**NEW MEXICO OIL CONSERVATION DIVISION**  
 - Engineering Bureau -  
 1220 South St. Francis Drive, Santa Fe, NM 87505

**APPLICATION FOR AUTHORIZATION TO INJECT**

WELL NAME & NUMBER: Centerpoint SWD #1

**from:** Jones; William V.; EMNRD  
**Sent:** Tuesday, October 25, 2005 1:32 PM  
**To:** J\_Williams@hydropuretechnology.biz  
**Subject:** SWD Application Centerpoint SWD #1 30-045-

# INJECTION WELL DATA SHEET

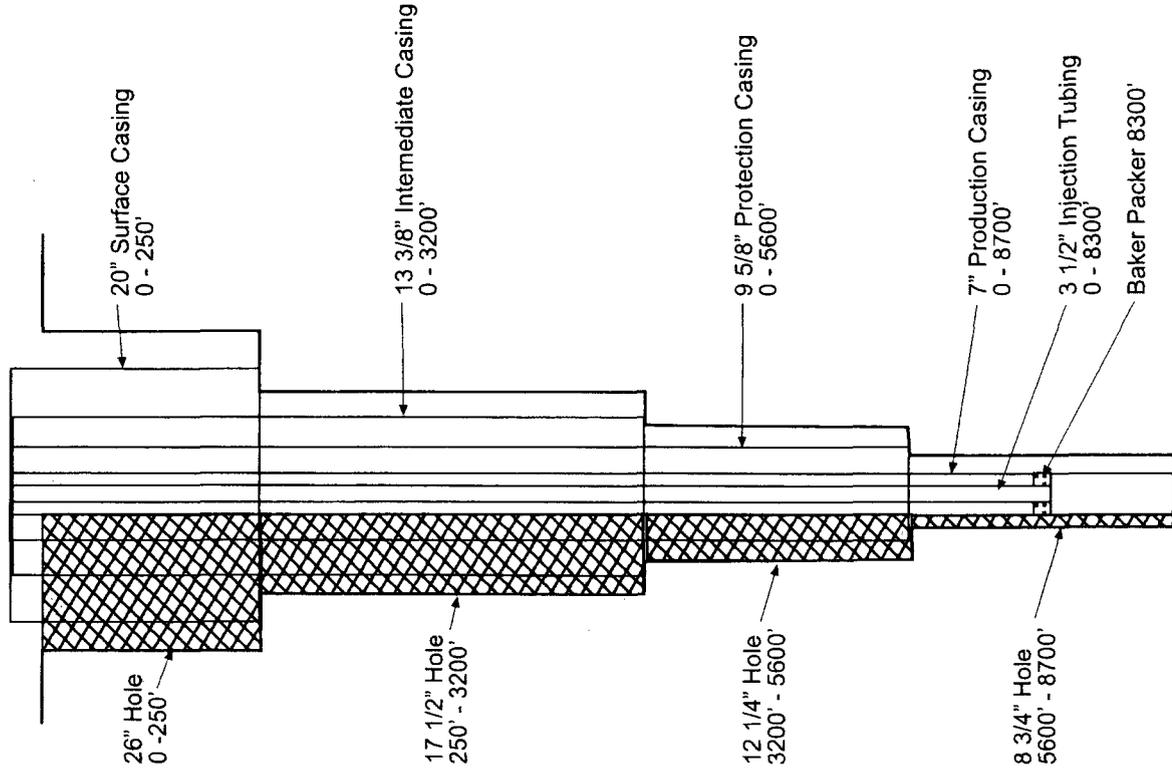
With regard to injection interval it is a bit of a guess at this point for exact footages. But to be safe I would say suggest 7,100 to 8,200 bgs for a potential injection interval. In reviewing this I noticed a typo in the answer provided for Form C108 VIII. On the form submitted we noted the Entrada interval as 8140' to 7090'. Boy that is some thick Entrada! The correct interval of clean sandstone should be approximately 8140' to 8090'. I have attached a revised answer for C108 VIII.

2) Our permits are depth specific, so please send your best guess of the absolute top and the absolute bottom of the interval you intend to inject - along with the correct formation names within this depth range. The permitted maximum surface injection pressure will be based on 0.20 times the upper perforation depth you apply for in your permit.

~~9350'~~ feet to ~~9600'~~  
7100'      \$2001
